FLOODPLAIN RESILIENCE PLAN

Planning and Sustainability Commission
Work Session

Attachment A

Decision Table 1: Staff Proposed Amendments to the Proposed Draft

Proposed Amendment A-1: Replacement
for Map 6 in the document

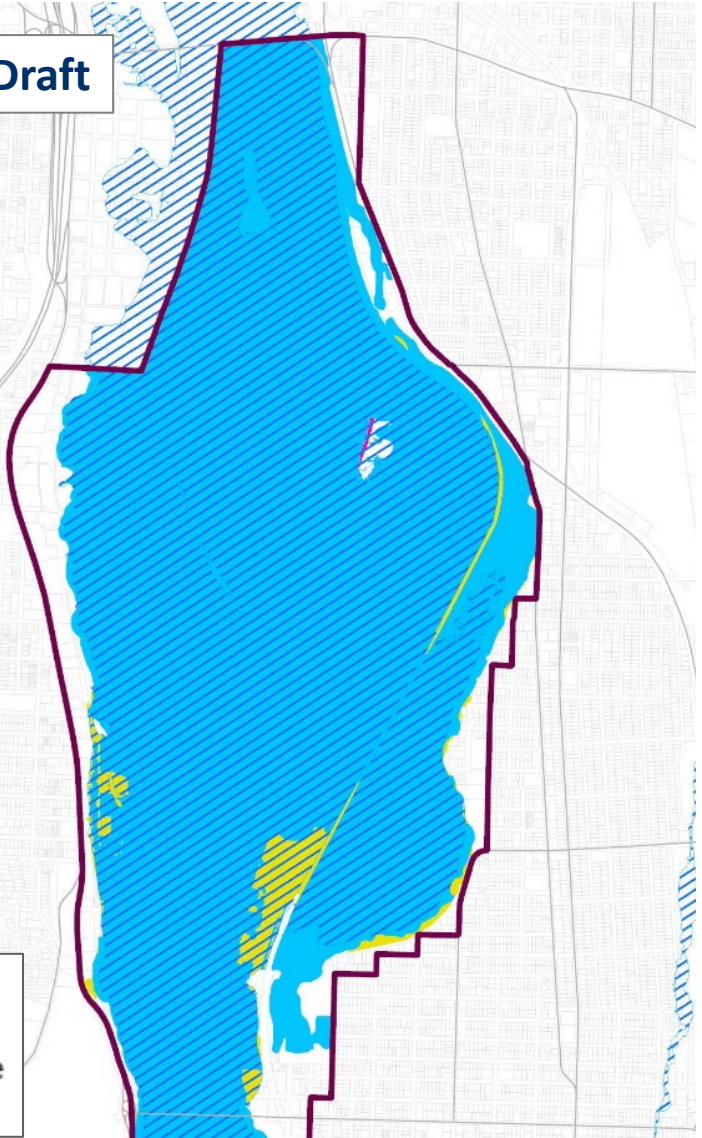
Ref #	Comment	Commenter(s)	Topic	Comment or Requested Amendment	Staff recommendation	Staff rationale	Discuss?	PSC decision
MAP AMENDMENTS								
<i>Amendment to Map 6, Proposed changes to the River Environmental Overlay Zone in the Willamette River South Reach</i>								
A-1	N/A	BPS Staff	Proposed South Reach River Environmental overlay zone	Modify the extent of the proposed River Environmental to apply it to the river setback, land within 100 feet of the top of bank, and all high- and medium-ranked riparian resources.	Replace Map 6, Proposed changes to the River Environmental Overlay Zone in the Willamette River South Reach, on page 52 of the Proposed Draft with the replacement Map 6 shown in the collection of maps in Decision Table A - Attachment 1.	The proposed River Environmental overlay in the Proposed Draft inadvertently removed some medium-ranked riparian resources that were not in the combined flood hazard area.	<input type="checkbox"/>	<input type="checkbox"/> Support staff rec. <input type="checkbox"/> Other

Proposed Amendment A-3: Modify proposed River Environmental overlay zone and riparian buffer area

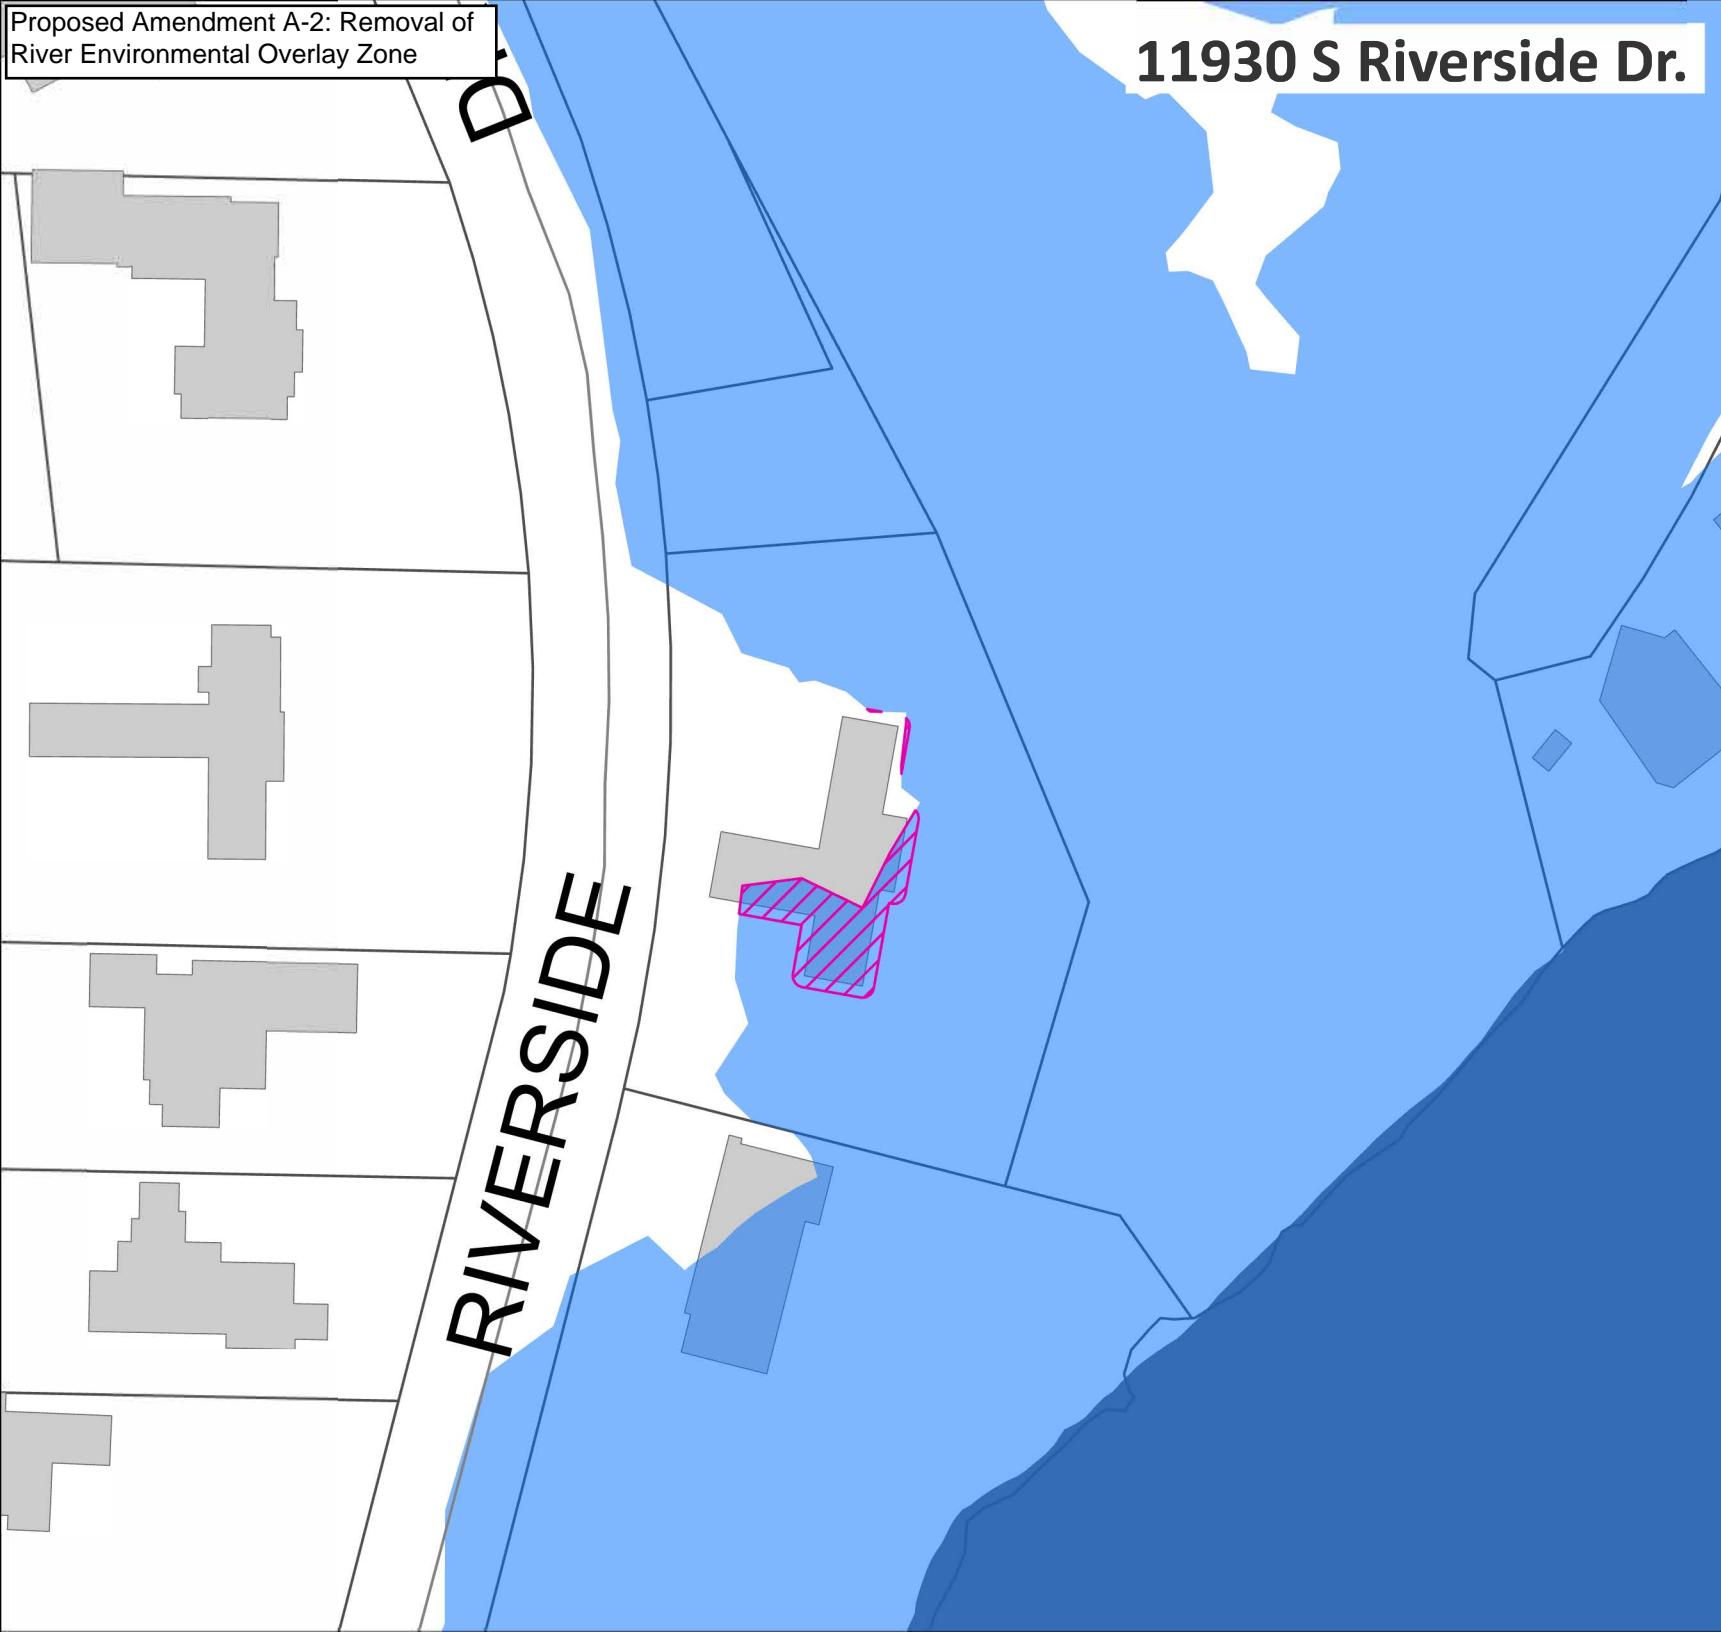
A-3	Call with BPS staff	Jim Kurtshaw	Modification of the proposed River Environmental overlay zone and riparian buffer area on Riverfront Place Condominiums site (NW Riverscape St)	Property owner at 1736 NW Riverscape St contacted City staff to request that the River Environmental overlay zone and riparian buffer area proposals be reevaluated because, as a part of the Riverscape development (around 2010), the site was removed from the FEMA 100-year floodplain through a FEMA Letter of Map Amendment based on the site characteristics.	Remove the property from the combined flood hazard area, as the FEMA 100-year floodplain is the only flood map relevant to the site (the Modeled Willamette River 1996 Flood Extent does not extend onto the property). With this modification of the combined flood hazard area, remove the proposed expansion of the River Environmental overlay zone and application of the riparian buffer area on the site. See the modification to the proposed River Environmental and riparian buffer area for this site in the collection of maps in Decision Table A - Attachment 1.	City staff determined that the property had been removed from the FEMA 100-year floodplain through a Letter of Map Amendment and the property should not be considered as a part of the combined flood hazard area. Therefore, the proposed expansion of the River Environmental overlay zone and application of the riparian buffer area on the site is not warranted.	<input type="checkbox"/>	<input type="checkbox"/> Support staff rec. <input type="checkbox"/> Other

Figure 510-2
South Waterfront Greenway Setback Area and Subareas

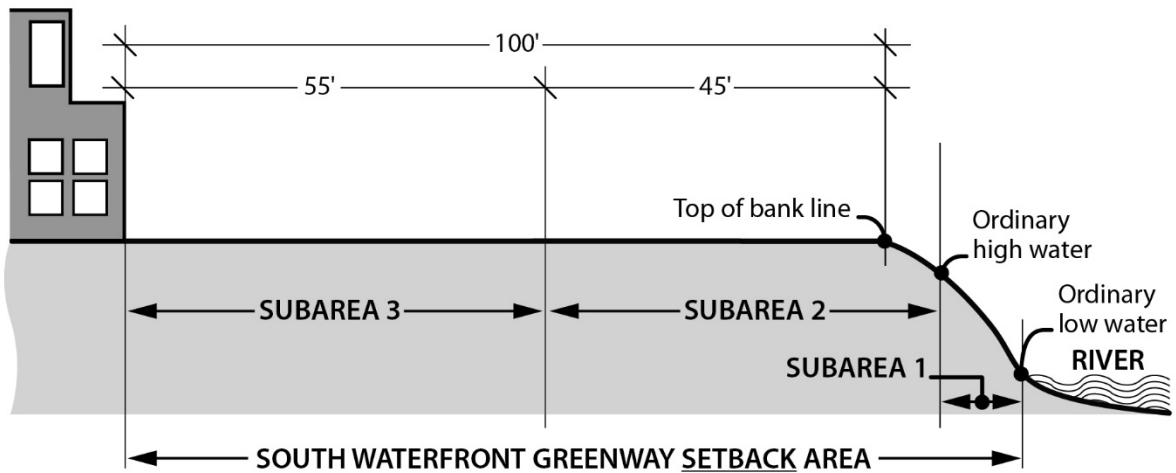
<i>Technical Amendments & Clarifications</i>								
A-11	332079	BDS Staff	Update Figure 510-2 in the South Waterfront Subdistrict (33.510.253.)	The text in Figure 510-2 should be updated throughout to include “South Waterfront Greenway <u>Setback</u> Area” throughout.	<p>Update Figure 510-2 to incorporate “setback” into the figure’s text where the “Greenway Area” is identified.</p> <p>For more detail, see all of the staff proposed code amendments in Decision Table A - Attachment 2.</p>	Not including “setback” was an oversight. It should be included in Figure 510-2.	<input type="checkbox"/>	<input type="checkbox"/> Support staff rec. <input type="checkbox"/> Other

Greenway Setback Area = from ordinary low water to 100' from top of bank line
Subarea 1 = from ordinary low water to ordinary high water
Subarea 2 = from ordinary high water to 45' in from top of bank line
Subarea 3 = from 45' in from top of bank to 100' in from top of bank line
